DEVELOPMENT REVIEW BOARD  
SUPPLEMENTAL SUBMITTAL

PROJECT NO. PR-2021-005411

DESCRIPTION: Updated Solid Waste Plan, Response to comments, Plat signed, Infrastructure list

**RE: AUTONATION - SITE PLAN  
DRB PROJECT NUMBER – 2021-005411**

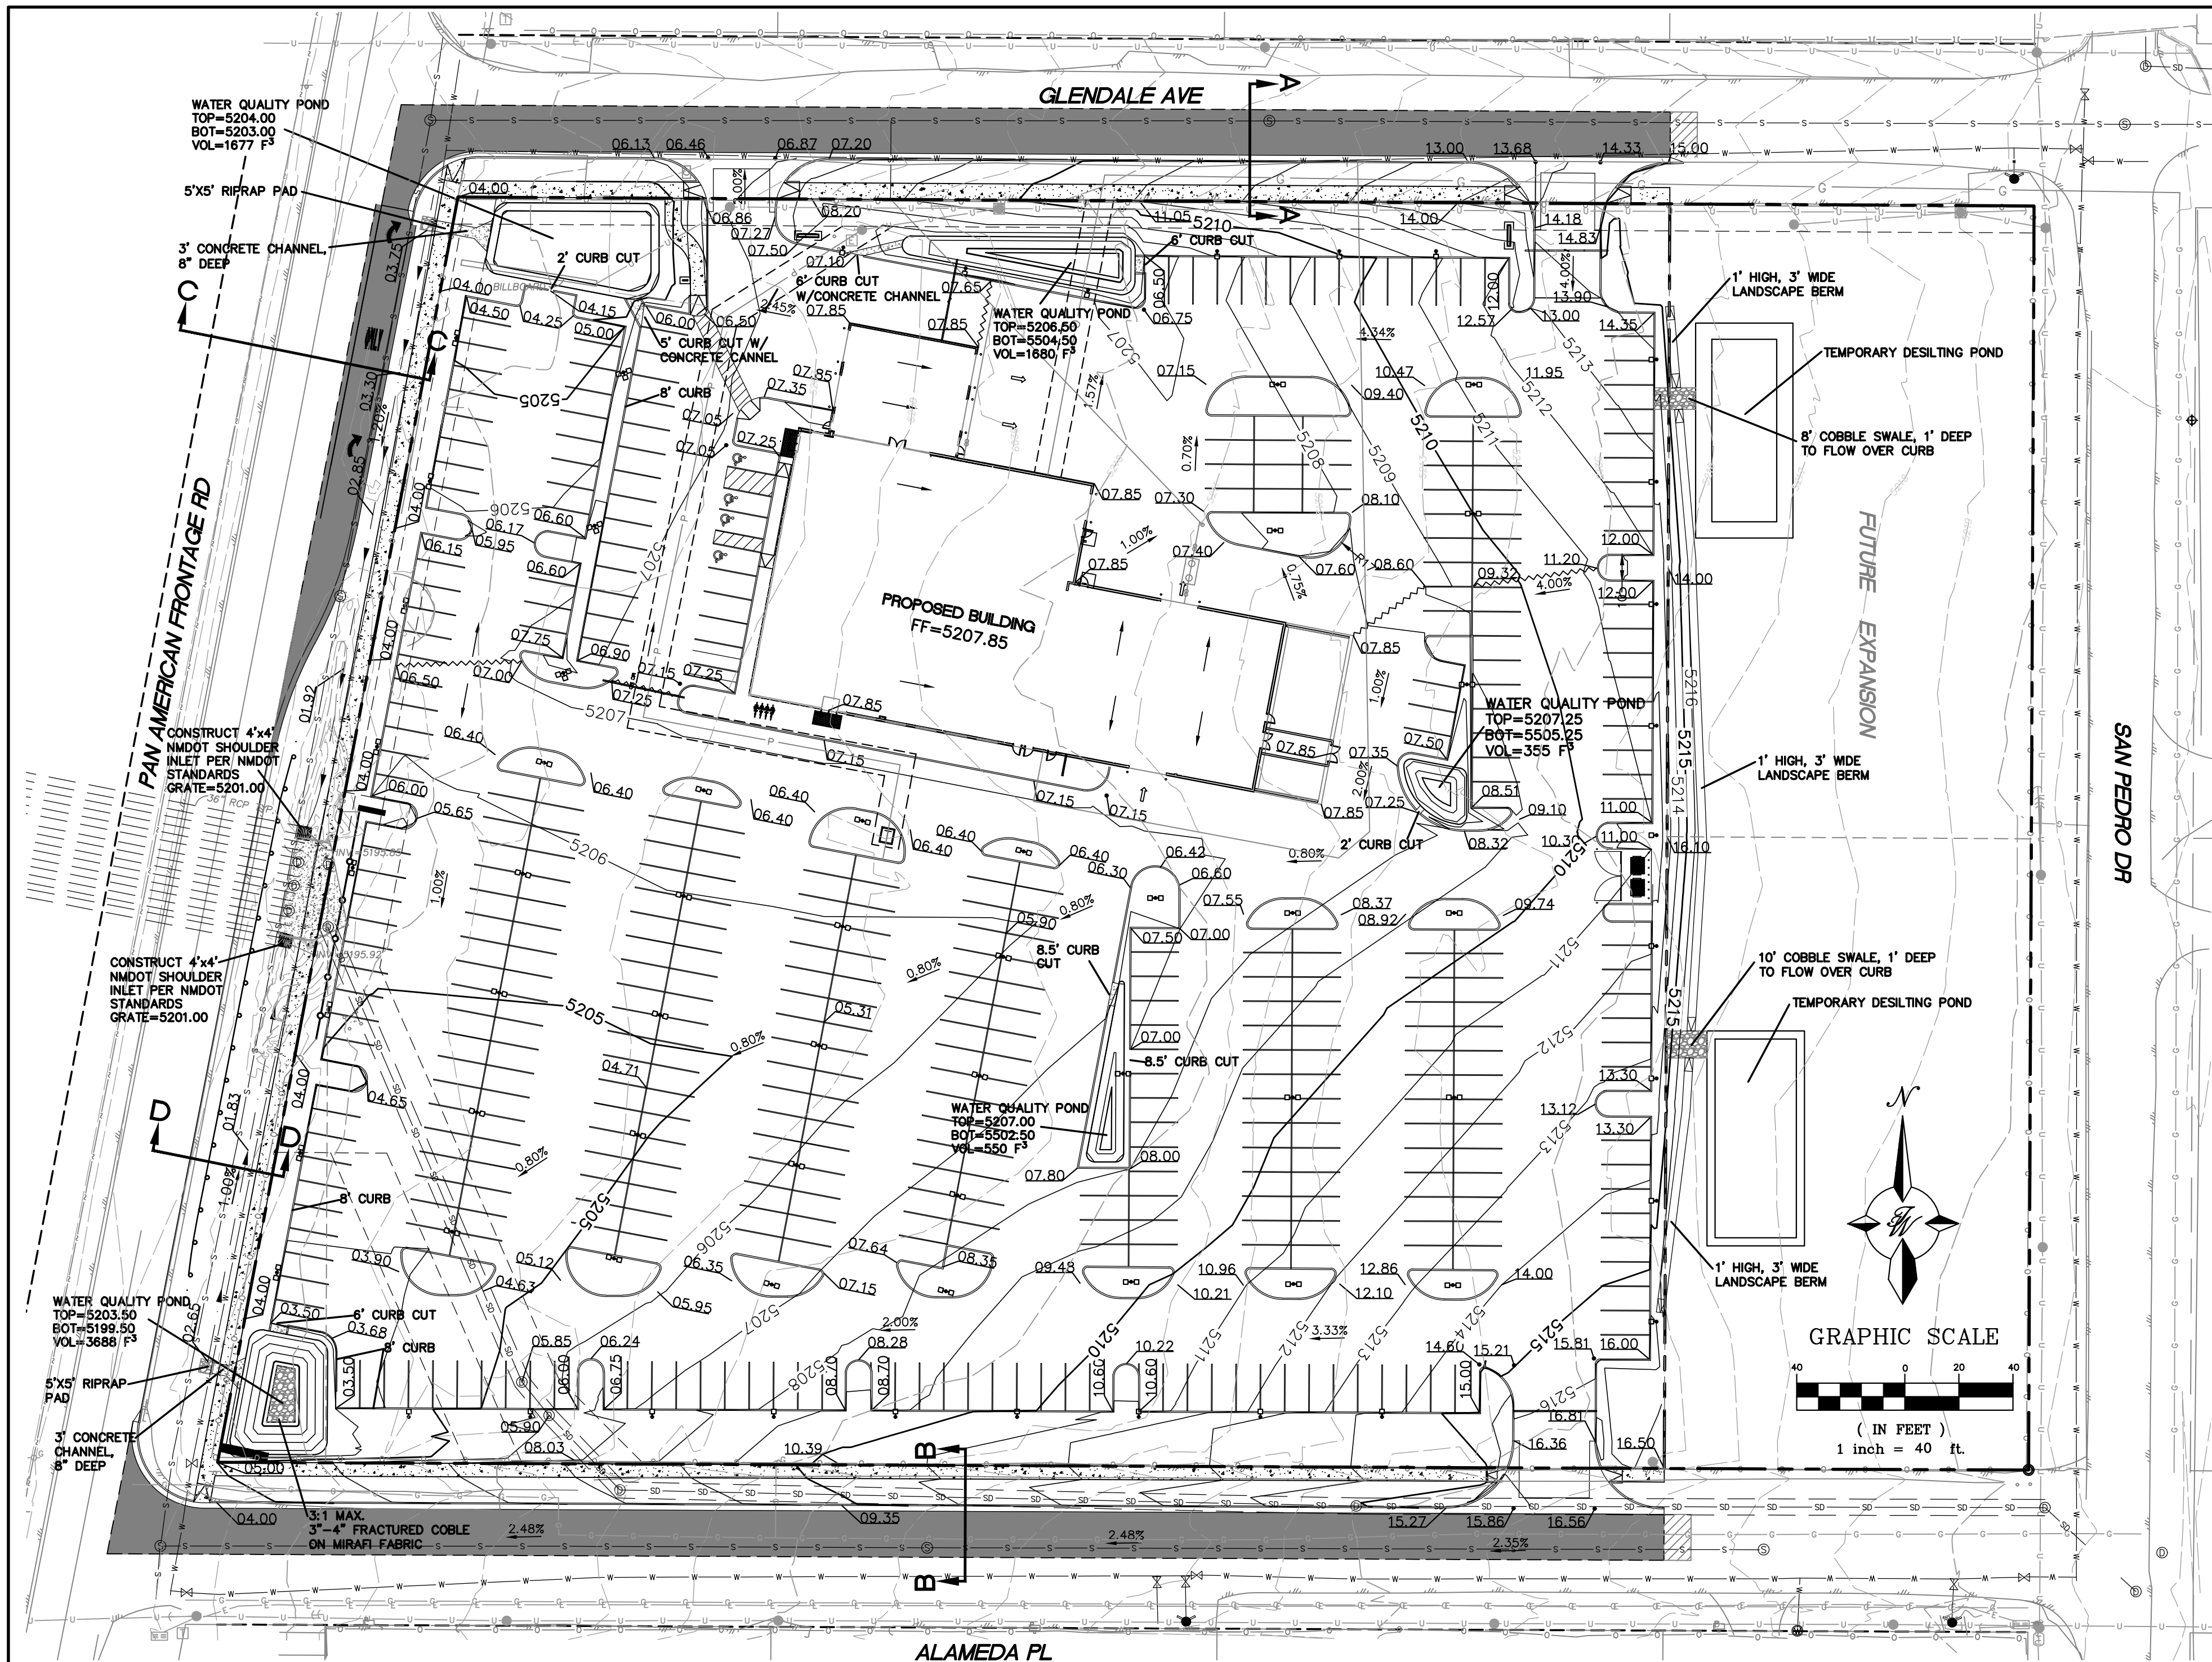
1. The site plan/grading plan call-outs for the sidewalk width do not match what is shown on the infrastructure list for Glendale and the frontage road.

3. Call out all curb ramps shown on the drawing with a keyed note reference. Adjust keyed note on the southwest corner of the site.  
**Keyed notes were added to the two ramps in front of the building.**

4. Move monument sign out of clear sight triangle.  
**The signs are not located in the clear sight triangle.**
5. A 6-foot ADA path is required between handicapped spaces and main door entrance. Label pathway as 6 feet and label door entrance.

**The sidewalk between the ADA parking spaces and the building was changed to be 6' wide.**

#### SERVICE AREA PARKING SIGN

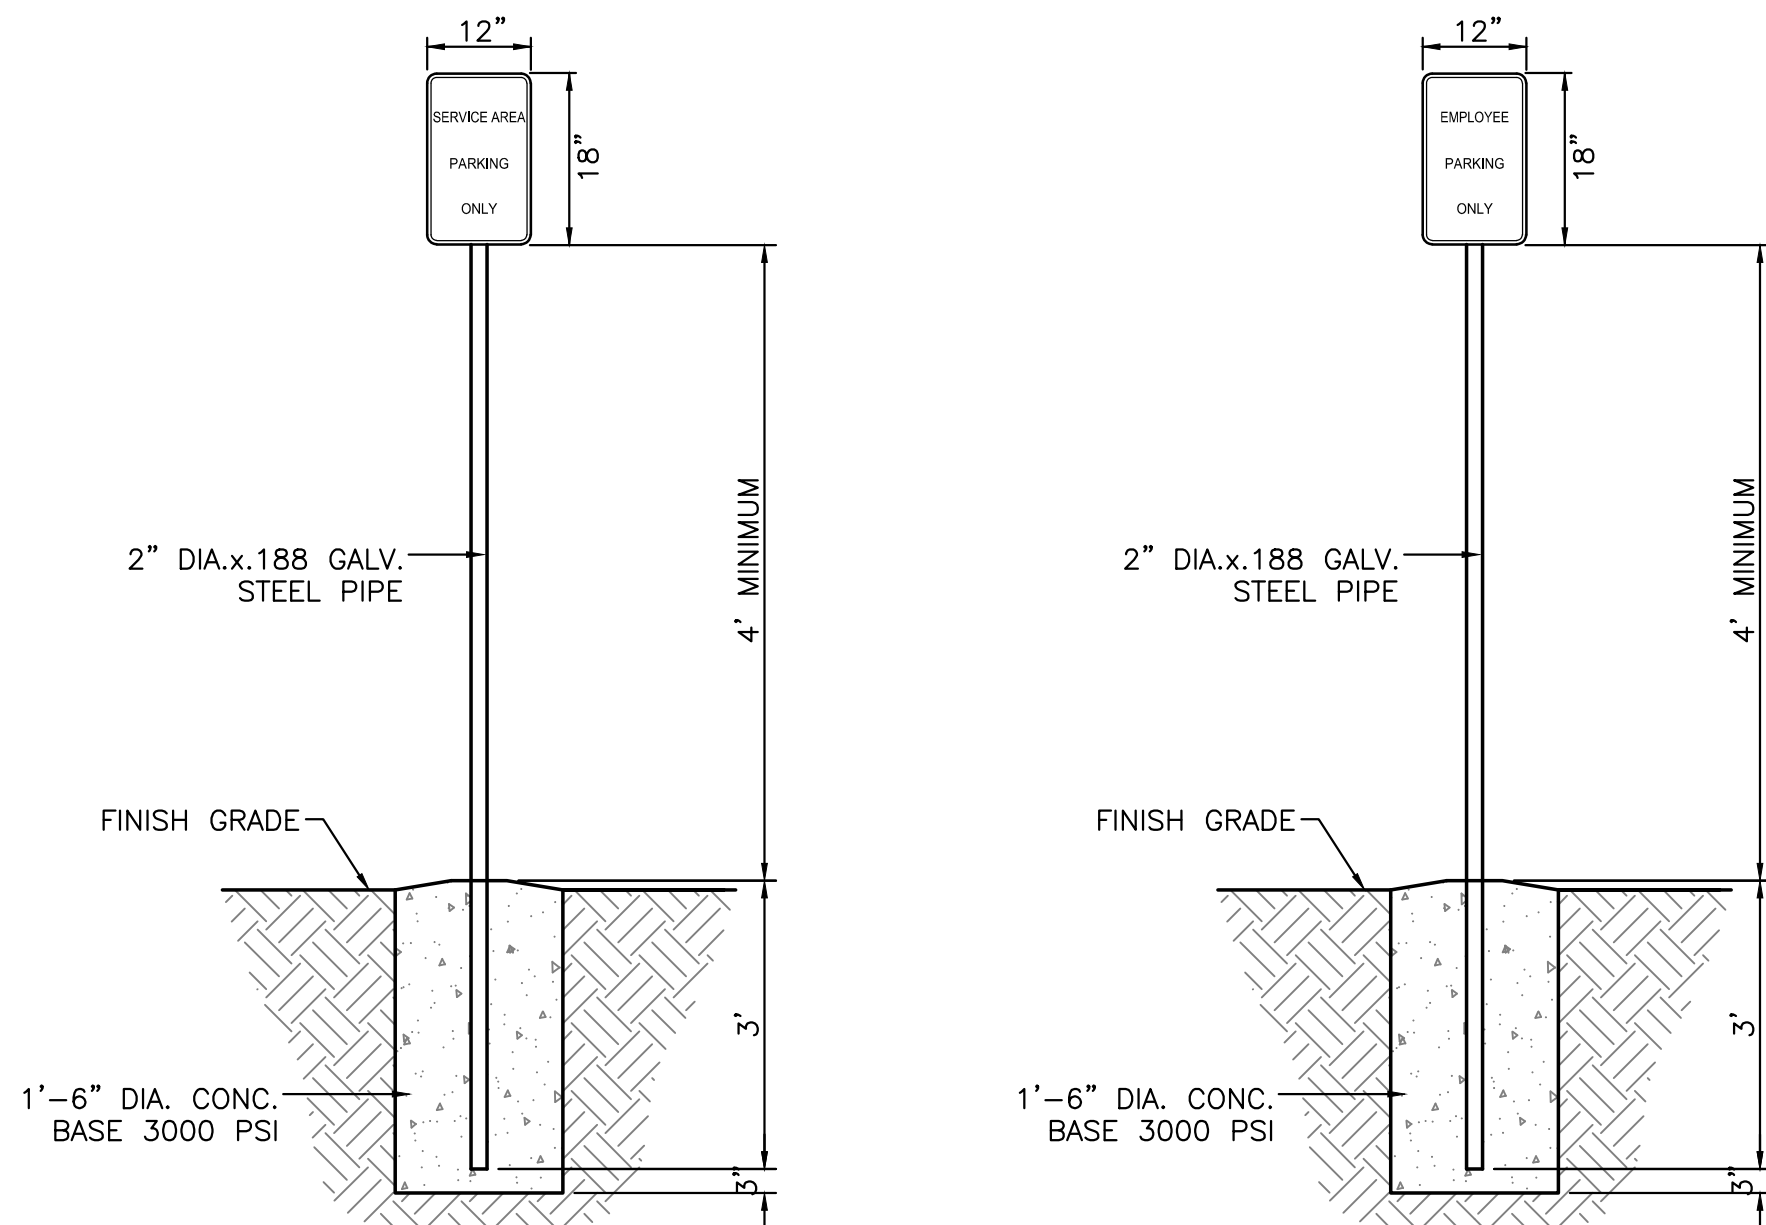
**The dimension and the keyed note were changed to reflect the width of 5'.**
2. Show signage for designated parking (service/employee parking).  
**Signs were added to the Site Plan and details provided on Sheet DET-1.**
